**Safety Evaluation Report
License Amendment for the Ludeman Project to the
Willow Creek In Situ Recovery Project
Converse County, Wyoming, Revision 1**

Materials License No. SUA-1341

Docket No. 040-08502

URANIUM ONE USA CORPORATION

Figure 2.4-3 Surface Water Features and Rights near Wellfields 1 and 2

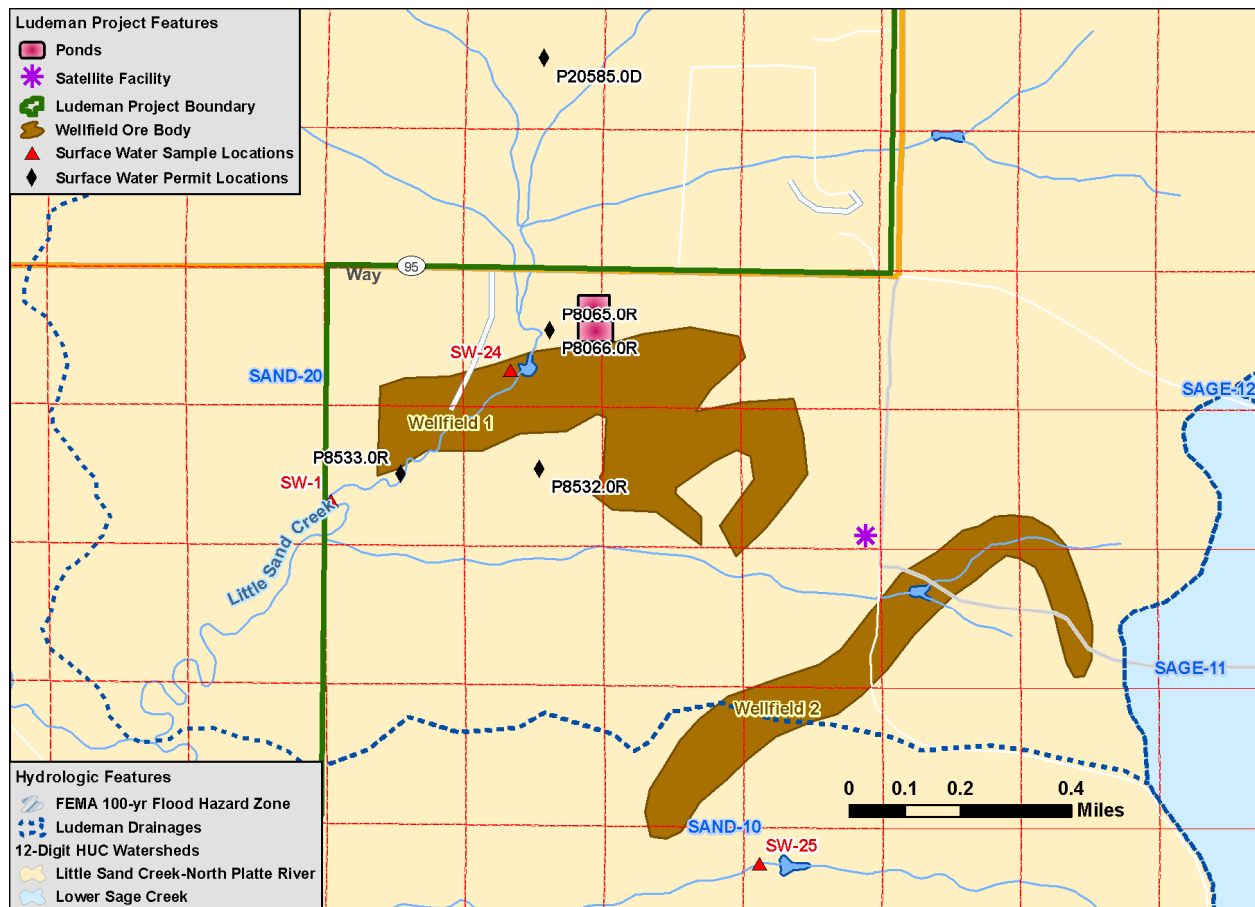
The NRC staff reviewed the FEMA 100-year flood hazards, surface water rights and sampling locations on a wellfield by wellfield basis. The surface water features near the Ludeman satellite facility and Wellfields 1 and 2 are shown in SER Figure 2.4-3. The satellite facility and both wellfields are located in the Sand -20 drainage of the Little Sand Creek sub-watershed. The southern tip of Wellfield 2 is located in the Sand -10 drainage. No FEMA 100-year flood hazard zones are present within or near the satellite facility or these wellfields.

The licensee reported there were five surface water rights within 2 km of Wellfield 1 and 2 as shown in SER Figure 2.4-3. The NRC staff reviewed the status of these surface water rights using the Wyoming State Engineers Office (WSEO) water rights database. The NRC staff found two of the surface water rights, P8065R and P8066R, were for two evaporation ponds used for liquid waste disposal at the historical Teton Pilot ISL. The historical location of the two ponds has been noted by the NRC staff on SER Figure 2.4-3 based on drawings from original 1983 Leuenberger Final Environmental Impact Statement (FEIS) (NRC 1983). The NRC staff determined that both of these ponds were decommissioned before the Teton Pilot ISL license was terminated (NRC 1986). In addition, the WSEO permits have been cancelled. Two other permits for impoundments, P8533.0R and P8532.0R, were also issued for the historical Teton ISL facility. The NRC staff determined these impoundments were never built and the WSEO permits were cancelled. The remaining surface water permit, P20858.OD, was issued in 1951 for storage of irrigation water and has expired. The NRC staff therefore finds there are no current surface water rights within 2 km of Wellfields 1 and 2.

The licensee reported it had located three surface water sampling points (SW-1, SW-24 and SW-25) near Wellfields 1 and 2. These locations were sampled to evaluate surface water quality before operations. A discussion of pre-operational water quality measured at these locations is provided separately in SER Section 2.5.3.1.

Figure 2.4-4 Surface Water Features and Rights near Wellfields 3 and 4

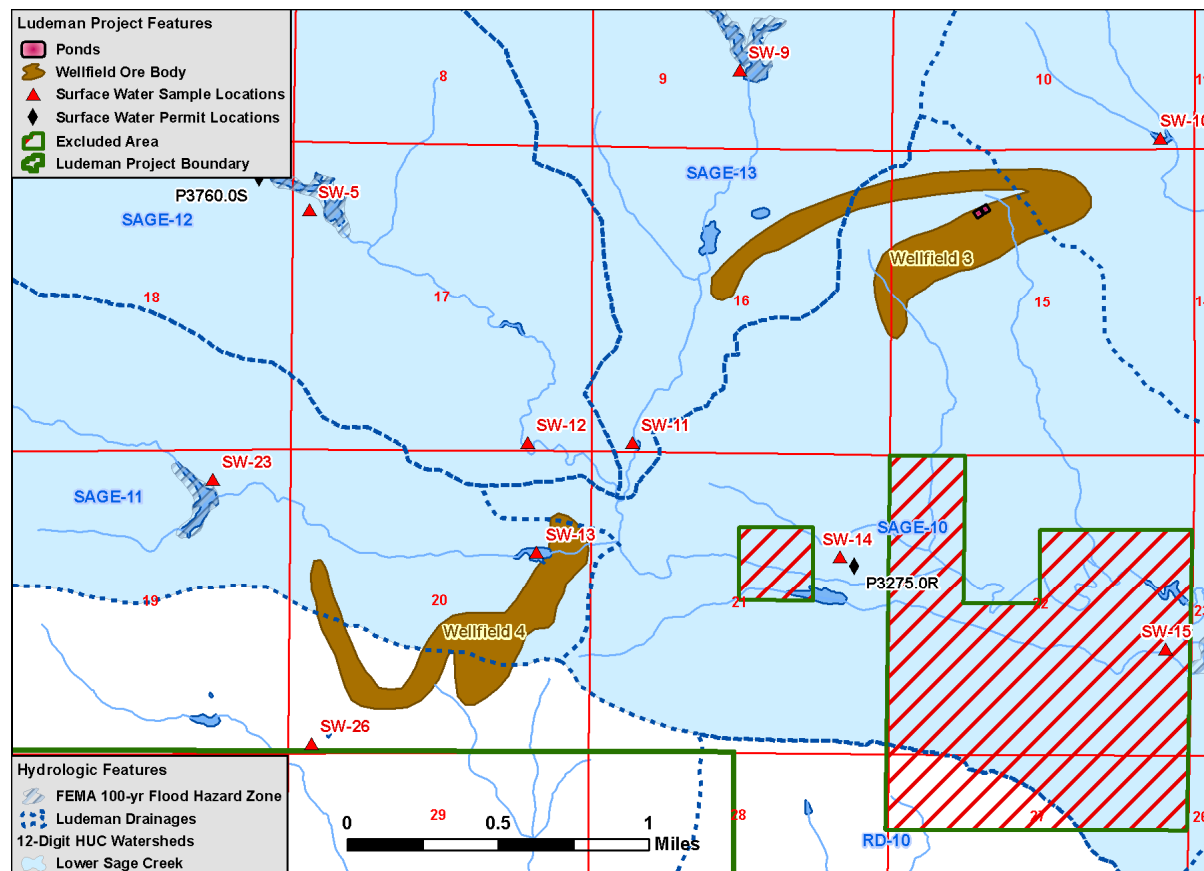
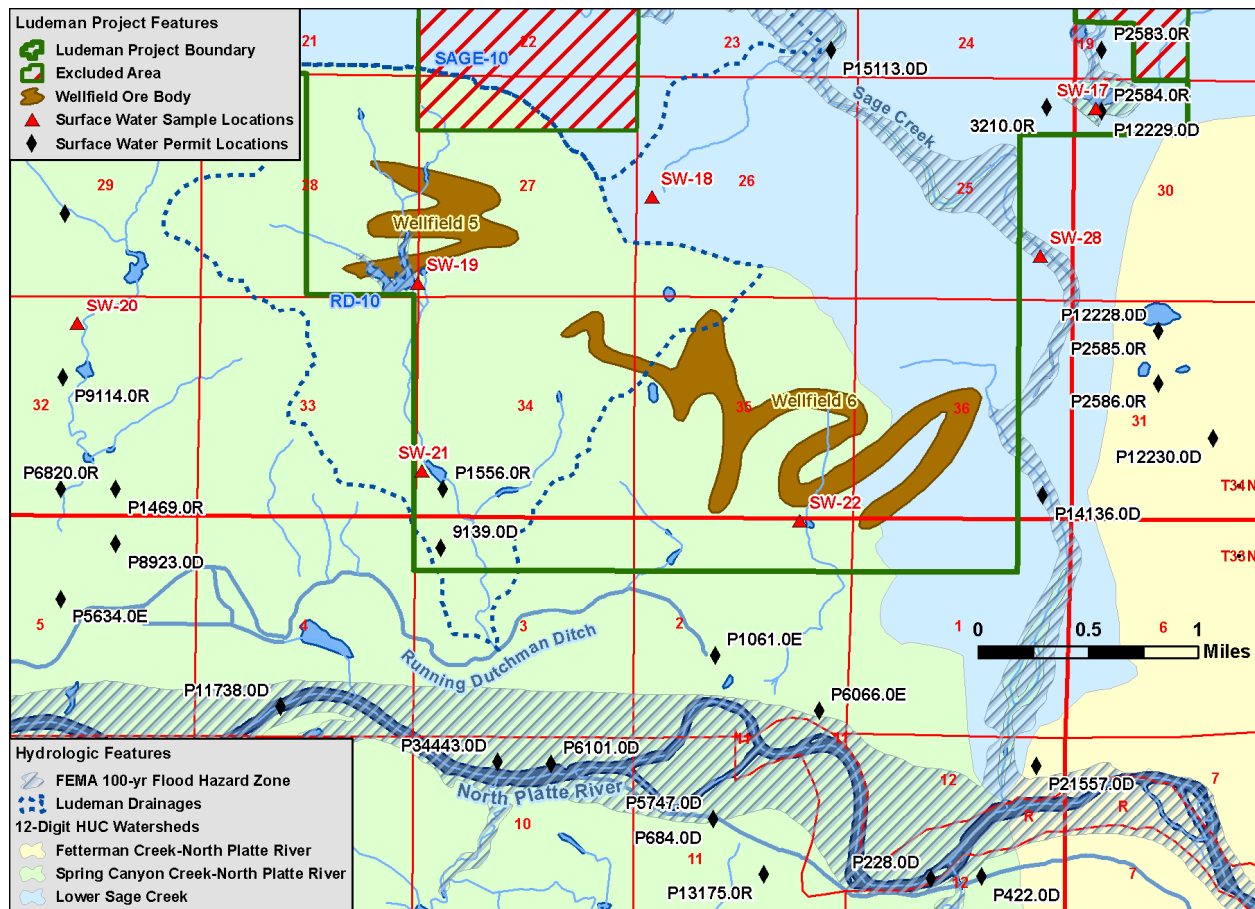
The surface water features near Wellfields 3 and 4 are shown in SER Figure 2.4-4. Wellfield 3 crosses the Sage -10 and Sage -13 subwatersheds and also lies within a small portion of unconcentrated flow within the larger Sage Creek watershed. Wellfield 4 lies mainly within the Sage-11 subwatershed and a portion of the RDD watershed. There are three water bodies designated as FEMA 100- year flood hazard zones near but not within these wellfields. NRC staff finds these 100- year flood hazard zones are located sufficiently distant from Wellfield 3 and 4 to not represent a significant source of flooding for these wellfields.

The location of surface water sampling sites near Wellfields 3 and 4 is shown in SER Figure 2.4-4. Surface water sampling points, SW-9 and SW-11, are located upgradient and downgradient, respectively, of Wellfield 3 in the Sage-13 subwatershed. Sampling points SW-5 and SW-12 located upgradient of both Wellfields 3 and 4 in the Sage-11 watershed. Sampling points SW-23 and SW-13 are located upgradient of Wellfield 4 in the Sage -11 subwatershed. SW-14 and SW-15 are located downgradient of both Wellfields 3 and 4. The NRC staff finds the location and spread of these sampling points sufficient for characterizing the pre-operational surface water quality near these wellfields. SW-5 and SW-14 were dry for the entire sampling period. The water quality reported for remaining surface water sampling sites did not display any anomalies of specific concern to the NRC staff.

Figure 2.4-7 Ground Water Rights and Private Wells within 2 km of Wellfields 1 and 2.

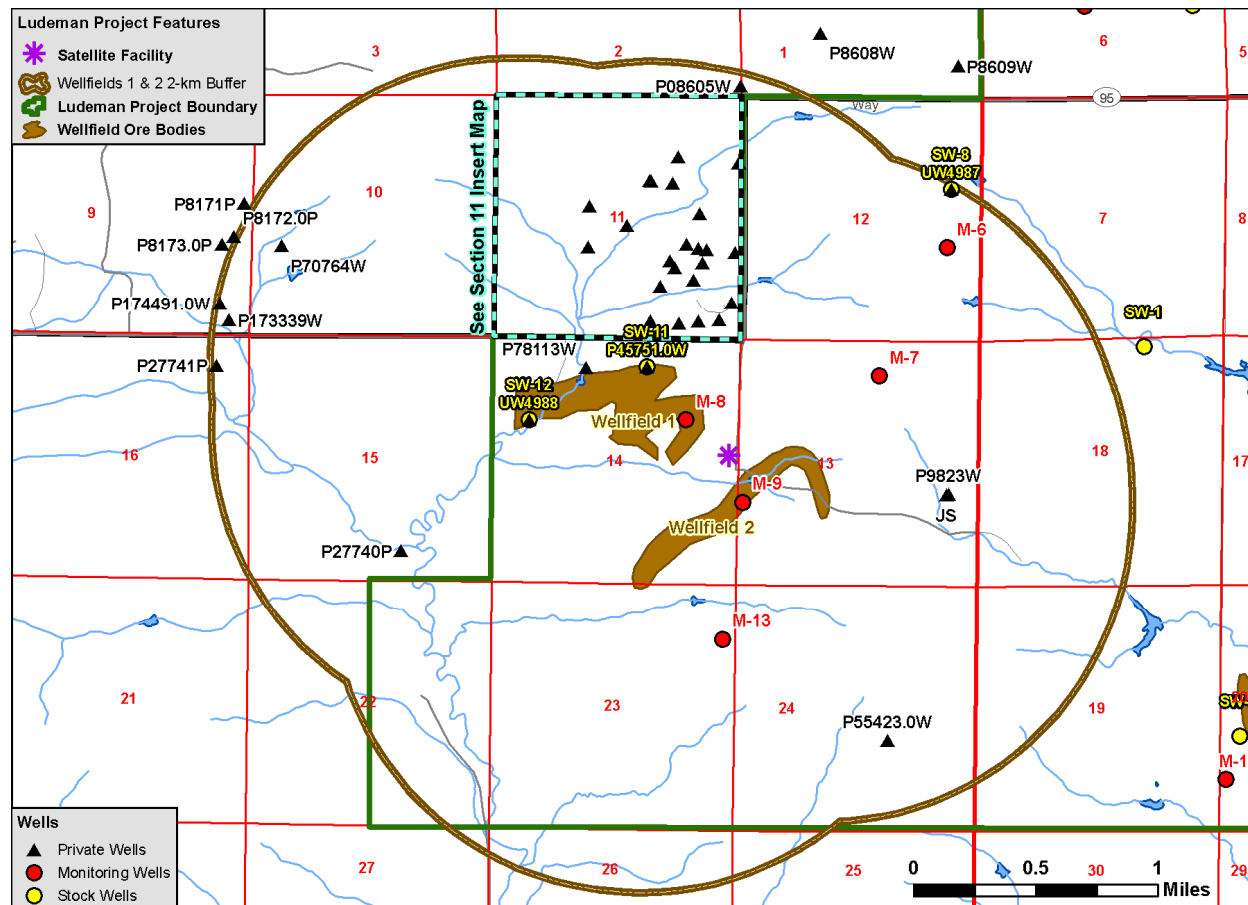
The NRC staff found only one domestic well, P9823W, identified by the licensee as the JS Well, was located in the license area at an estimated distance of 5475 ft from Wellfield 1. The licensee reported this well is currently associated with a residence and used for domestic purposes. The NRC staff reviewed the WSEO permit for the well, P9823W, and found it is reported as deepened to 160-180 ft. The NRC staff located the closest boring log (3473-18-1004) to this well on Cross Section C-C' in Figure 2.6A-7 of Addendum 2.6-A of the Ludeman Project Revised Technical Report (Uranium One USA 2017d). At this location and depth, Cross Section C-C' indicates the well is most likely completed in the 110 or 100 sand which overlies the 90 and 80 sand ore zones in Wellfield 1.

The licensee reported and the NRC staff found many of the private wells in Negley Subdivision are located close to Wellfield 1 as shown in SER Figure 2.4-7. The NRC staff estimated the distance of these wells to the nearest Wellfield 1 boundary as shown in SER Table 2.4-11. The closest wells, N-2, N-19, N-12 and N-16, which are all domestic, are located less than 1500 ft from the boundary of Wellfield 1.

Figure 2.4-8 Ground Water Rights and Private Wells within 2 km of Wellfields 1 and 2 in Section 11.

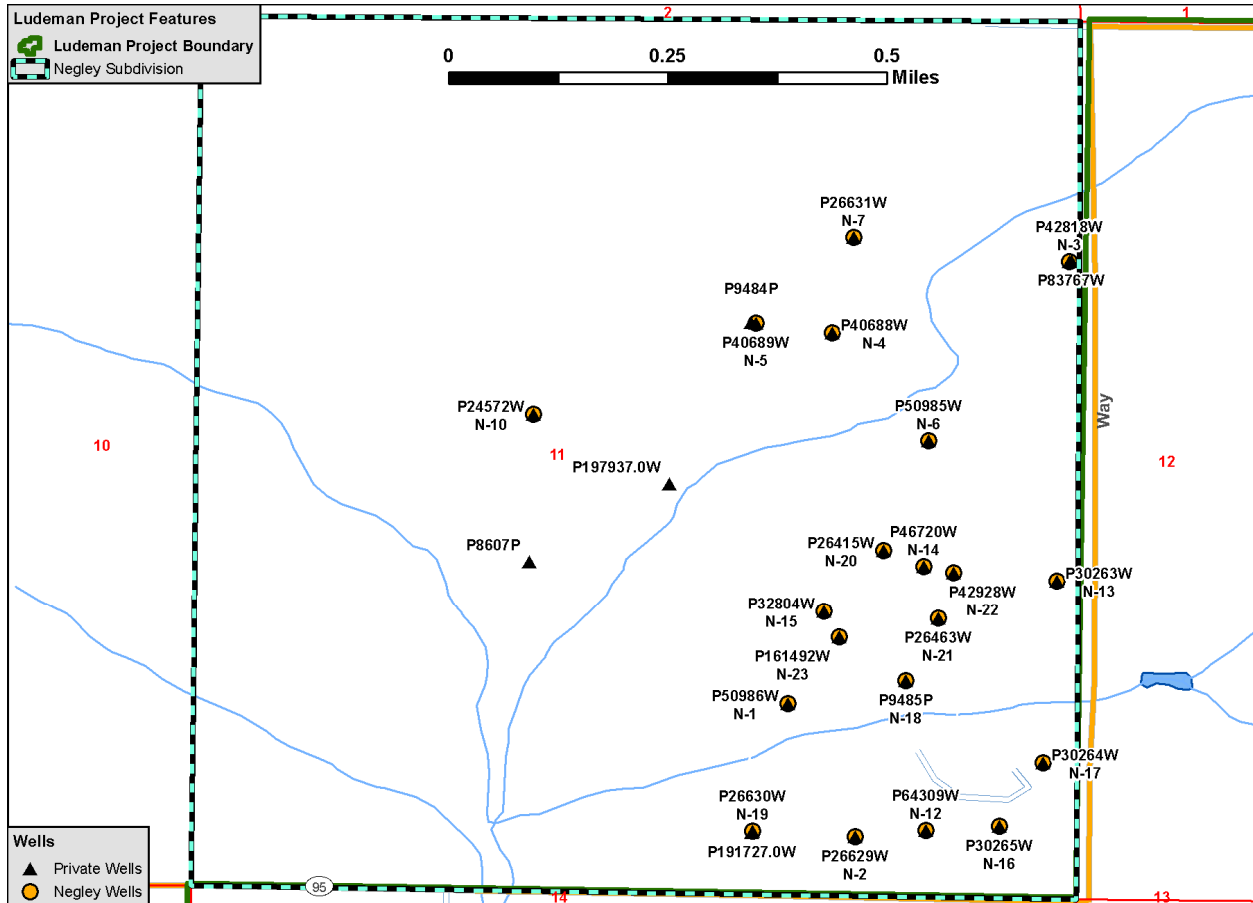
In conclusion, the NRC staff finds these private wells are hydrologically isolated from the 80 and 90 production zone sands at Wellfield 1, as they are located in overlying or underlying sands which are separated by competent confining aquitards as described in SER Sections 2.3.3.2 and 2.4.3.2. Staff found that one domestic well, P173339W, one stock well, P55423W, and one irrigation well, P177491.0W, were completed in the 80 or 90 sands. These wells are located almost 2 km from Wellfield 1 or 2, which NRC concludes is a sufficient distance to support a finding of hydrologic isolation. The licensee reported and the NRC staff confirmed that numerous ground water rights and private wells are located in Section 11 of T34N R74W which

is outside the license area but within 2 km of Wellfield 1. The licensee stated that Section 11 contains a large unplatted acreage neighborhood known as the Negley Subdivision. The NRC staff mapped the location of these ground water rights in SER Figure 2.4-8. This figure shows not only the WSEO permit numbers but also the numbers used by the licensee to identify the existing Negley Subdivision wells (e.g. N-1).

Figure 2.4-11 Ground Water Rights and Private Wells within 2 km of Wellfields 5 and 6

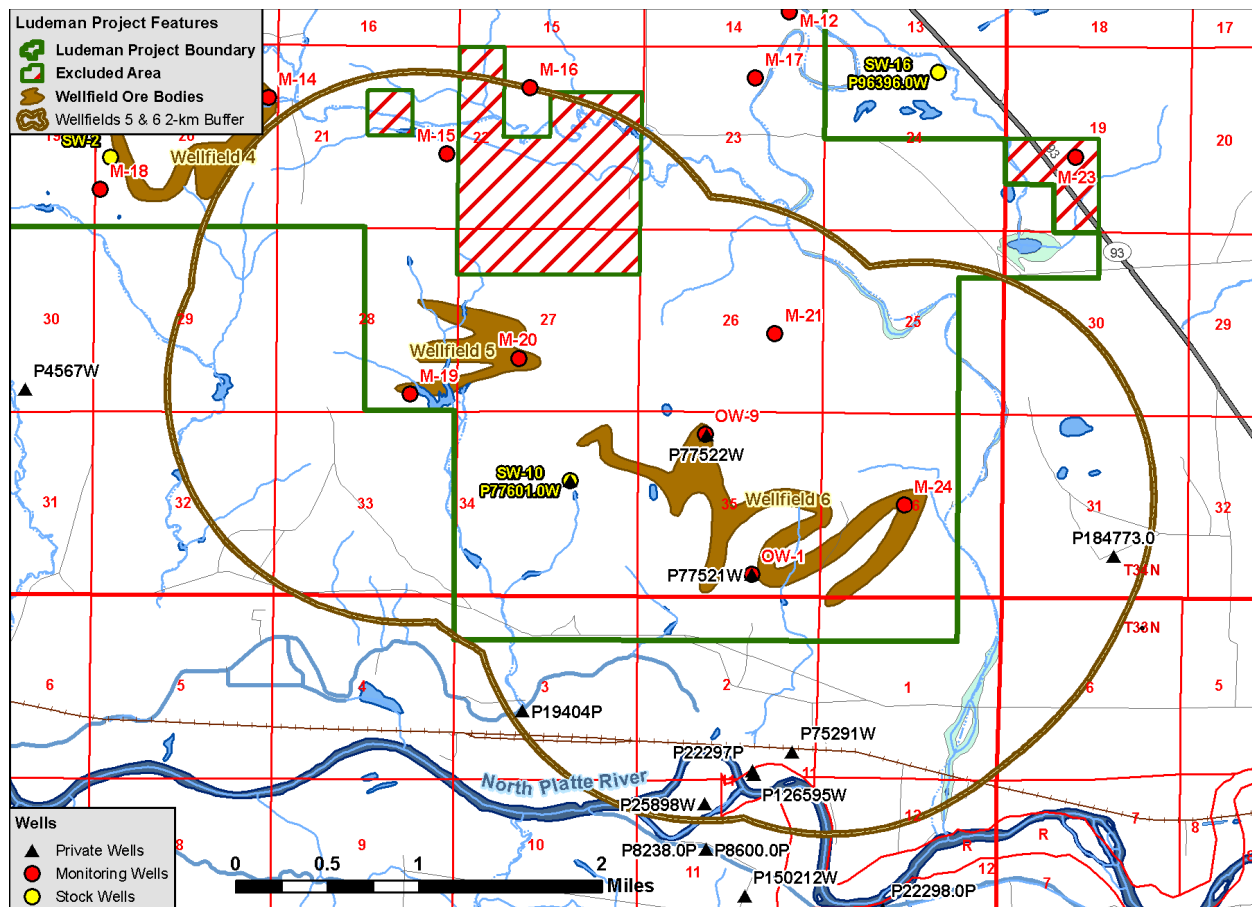
Wellfields 5 and 6 are located in T34N R73W Sections 27, 28, 34, 35 and 36 in the far southeastern corner of the license area. The NRC staff determined there are nine ground water rights within 2 km of Wellfield 5 and 6 using licensee provided information and an independent review of the WSEO water rights database. The location of these ground water rights were mapped by the NRC staff as shown in SER Figure 2.4-11. This figure also shows the WSEO permit names and the names used by the licensee to identify specific private wells (e.g. SW-14) in the Ludeman Project Revised Technical Report (Uranium One USA 2017d). All of these water rights are associated with private domestic or stock wells. The ground water rights, well name, well completion information, and permitted use within 2 km of are shown in SER Table 2.4-14.

The private well completion descriptions as provided by the licensee are shown in SER Table 2.4-14. Well P77601.0W (SW-10), with a screen interval of 140-165 ft bgs, is located west of Wellfield 6. The NRC staff determined it was completed in the 90 sand based on the nearest log point 3473-NAC23-835 of Cross Section F-F' in Figure 2.6A-10 of Addendum 2.6-A of the Ludeman Project Revised Technical Report (Uranium One USA 2017d). The 90 sand is the production ore zone aquifer in Wellfield 6. In the table in Addendum 2.7-C, the licensee reported that Well P77521W (OW-1) and Well P77522W (OW-9), both stock wells, were completed in the 80 and 60 sands. The NRC staff, however, determined that Well P77521W (OW-1) with a well screen depth of 127-167 is likely to be completed in the 90 production zone sand based on the nearest log point 3473-35-2018 on Cross Section T-T' Figure 2.6A-24 of Addendum 2.6-A.
